## BW1116 vs BW1117

## Wholesale Trailer Supply

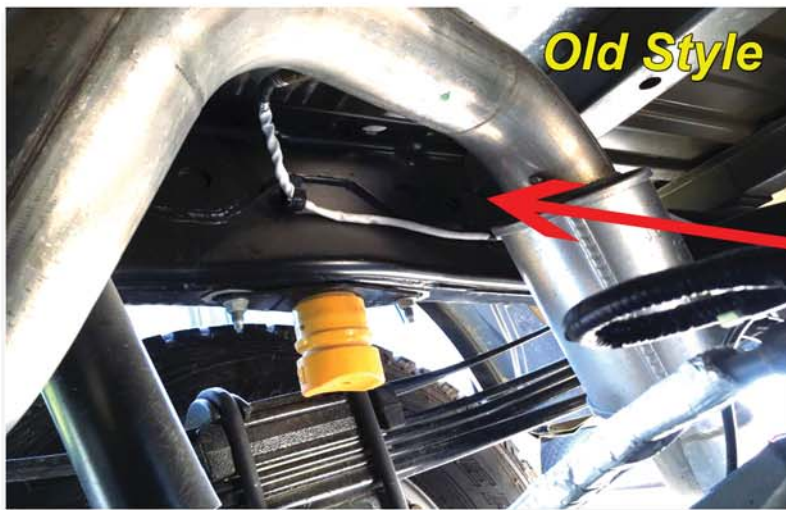
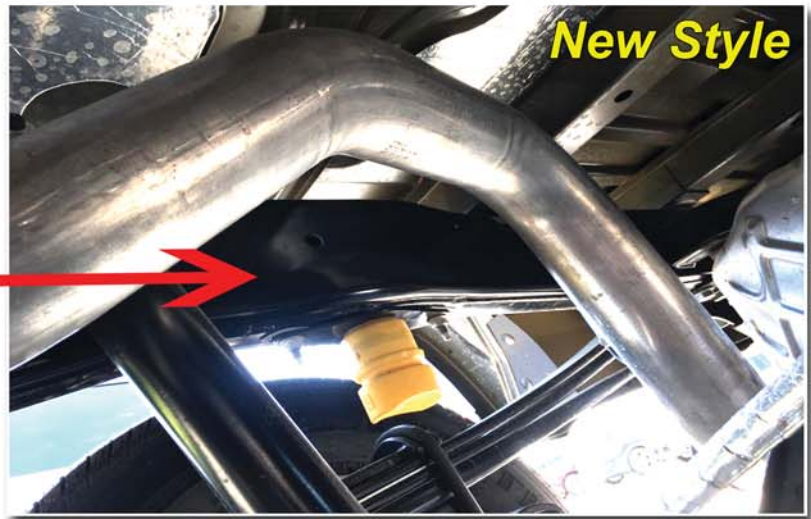
B&W has discovered that Ford made a mid-year change to their 2019 truck frame. This change will affect the fitment of gooseneck hitches on some of their trucks. Only 2019 trucks are subject to this change. Ford is no longer welding side plates to the inner frame above the yellow bumper over the rear axle. The change can only be confirmed with a visual inspection of the vehicle.

Picture shows 'No' inner side plates welded on frame.  
**New Style**

Picture shows 'Yes' inner side plates welded on frame.  
**Old Style**

**BW1116** Will include the additional mounting plates/spacers if needed for the new 2019 trucks  
**BW1116** Will fit **2017, 2018** and **2019** trucks, refer to B&W fit guide for models included

**BW1117** Will fit **2017, 2018** and some early **2019** trucks (with welded on side plates from factory)  
**BW1117** Will be phased out of production do to the change in Ford's frame
